Re: *Addendum No. 1*
Howard Court Sanitary Sewer Line Replacement
Village of Hartville

Date: February 24, 2025

This Addendum forms a part of the contract documents and modifies the original bidding documents dated February 2025 and all previous addenda, if any. Acknowledge receipt of this addendum in the space provided in the bid forms. Failure to do so may subject the bidder to disqualification.

GN-01

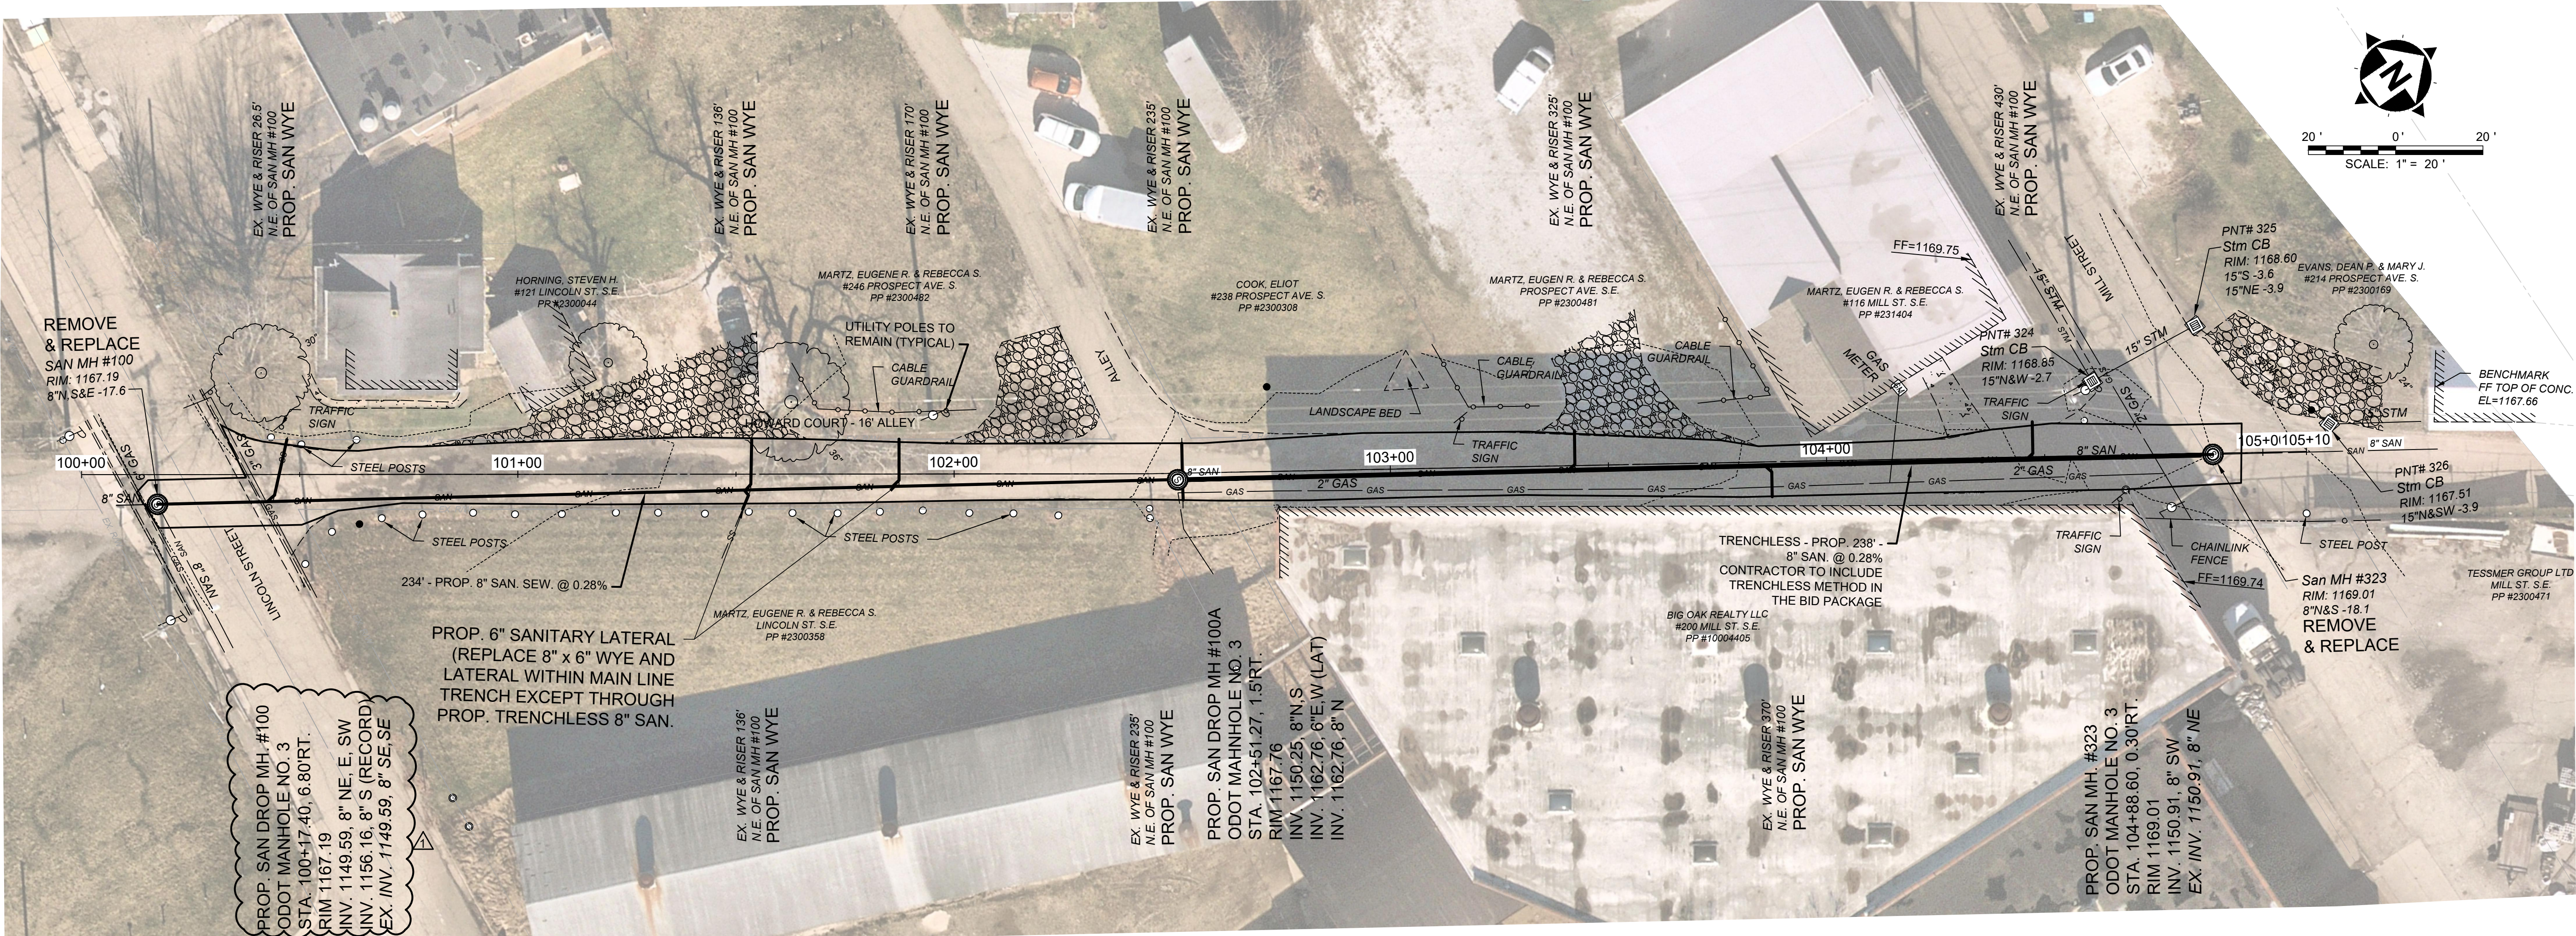
6. SEWERS FROM MH #100A TO MH #323 SHALL BE CONSTRUCTED BY TRENCHLESS MEANS AND METHODS. FINAL MEANS AND METHODS FOR THIS SECTION ARE SUBJECT TO CONTRACTOR'S PREFERENCE PENDING VILLAGE OF HARTVILLE APPROVAL. **THE METHOD DESCRIPTION TO BE INCLUDED IN THE BID PACKAGE.** APPROVAL FOR MEANS AND METHODS SHALL BE DEPENDENT ON ABILITY TO MEET THE FOLLOWING CRITERIA:

C.1 ALL PIPE SLOPES SHALL MAINTAIN A MINIMUM SLOPE OF 0.2% OR GREATER. SLOPE SHALL BE CONSISTENT BETWEEN MANHOLES.

D. CONTRACTOR SHALL INSTALL DROP STRUCTURES IF INVERTS ARE MODIFIED AND PIPE INLET INVERT ABOVE THE MANHOLE INVERT IS 24" OR GREATER.
